Technical design note

Project name	Himley Village, Bicester - Reserved Matters Application		
Design note title	Discharge of Condition 11 - Supplementary Information		
Document reference	27141-HYD-XX-XX-TN-C-0005		
Author	B. Tawton		
Revision	PO1		
Date	27 October 2023	Approved

The following Technical Note is to be read in response to LLFA's comments on the Discharge of Condition application reference 23/00207/DISC regarding the site wide surface water drainage strategy for the Proposed Himley Village development site.

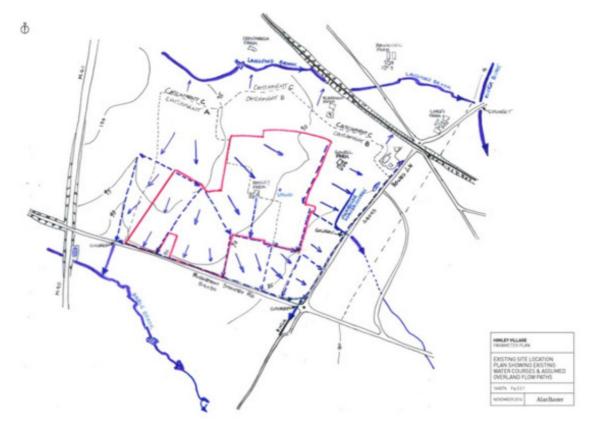
As an agricultural greenfield site, the application site benefits from numerous ditches to control surface water runoff, this network of ditches can be viewed in Figure 3.3 of the Ala Baxter FRA (reproduced below).

The existing ditches within the application site form a land drainage network to serve the site and convey surface water to existing offsite water courses. The site predominantly falls to the south and east and drains into the ditch that runs parallel to the Middleton Stoney Road (B4030). The Middleton Stoney Road ditch is culverted along the recently completed commercial development (to the south east) before discharging into the Gable Brook (see extract above).
